**Invitation for Bid No. 2023-063**

**Grassy Branch Cured-In-Place Pipe Lining**  
.....

**ADDENDUM No. 1**

**ISSUE DATE: May 18, 2023**

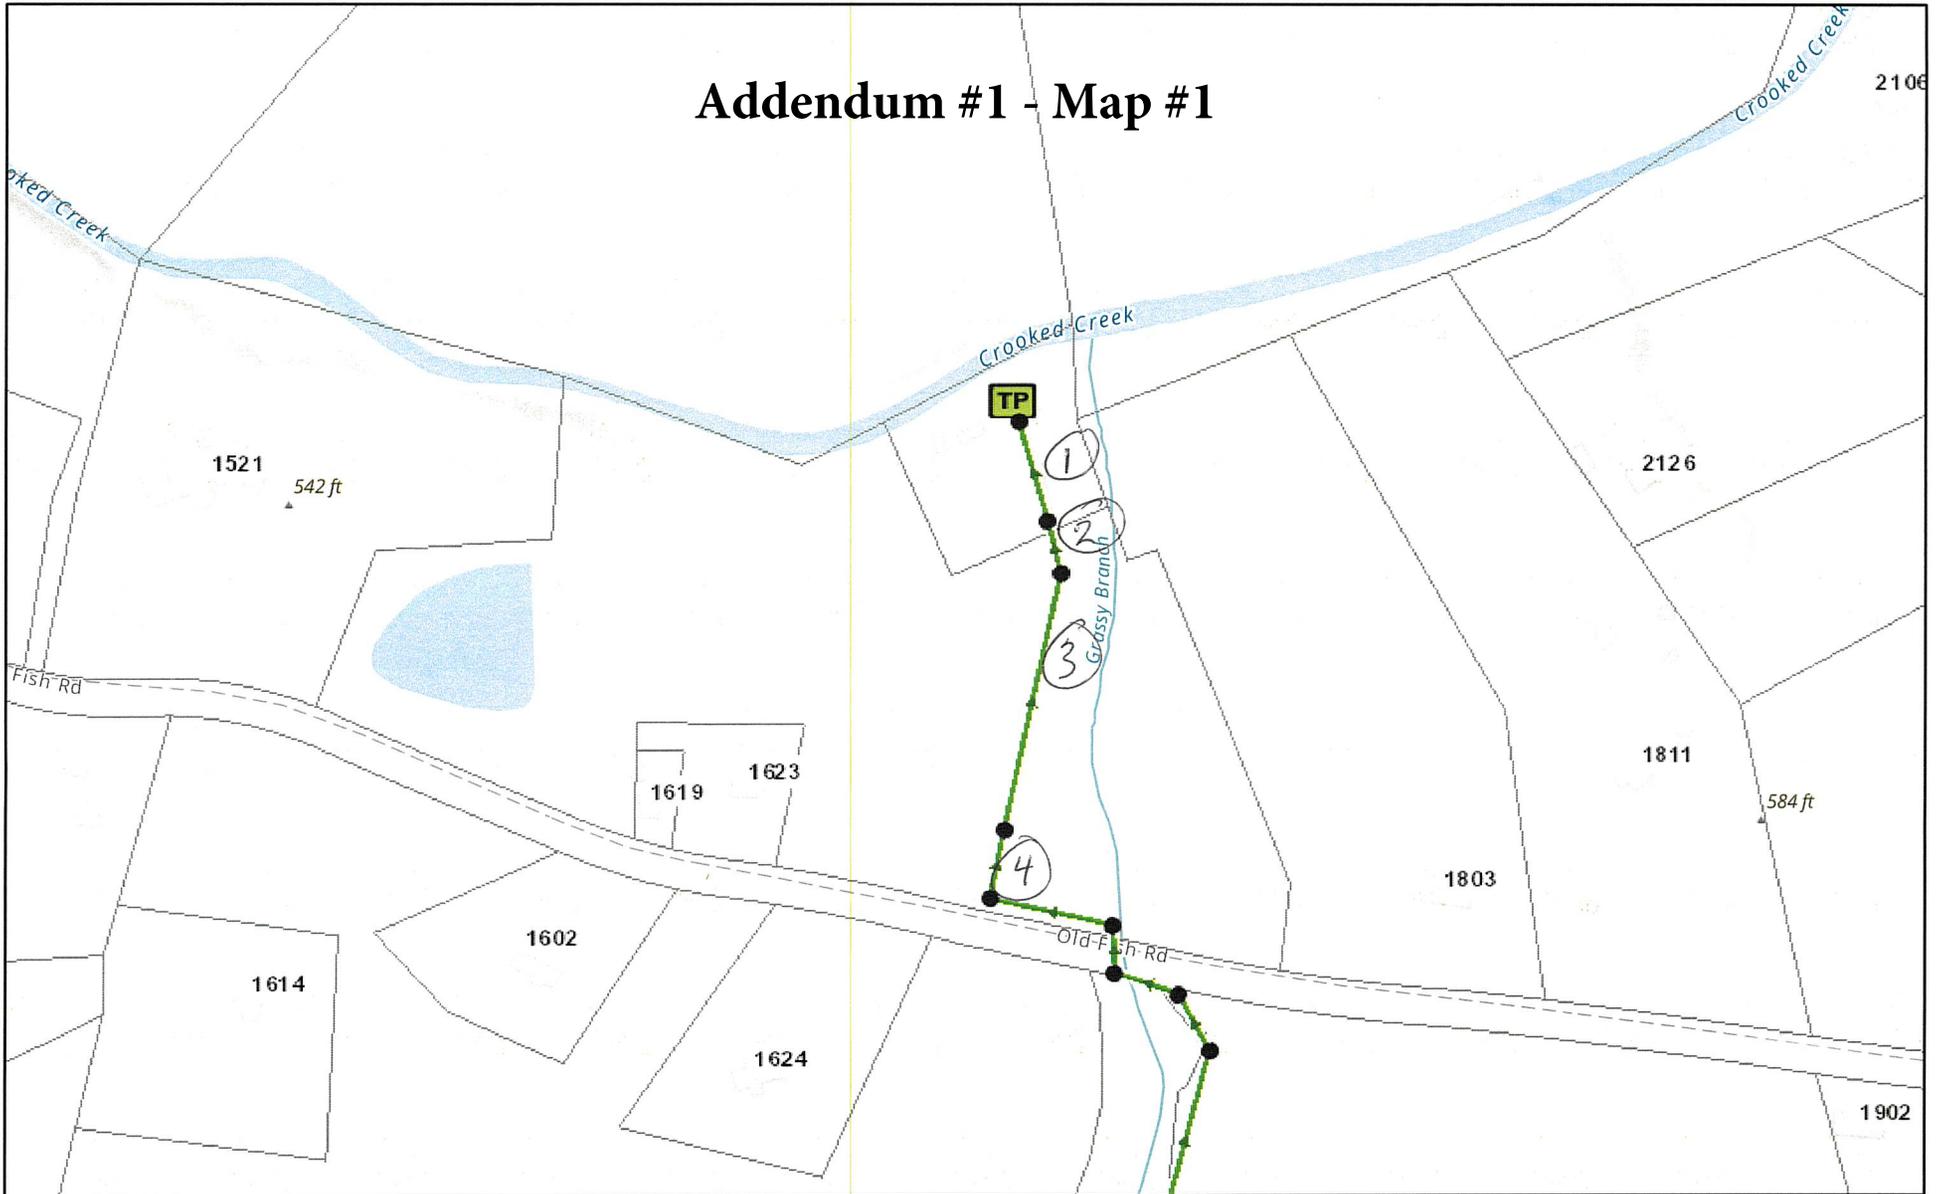
5. **Question:** Is the below the only map available?

**Answer:** Refer to Section A) Item #1
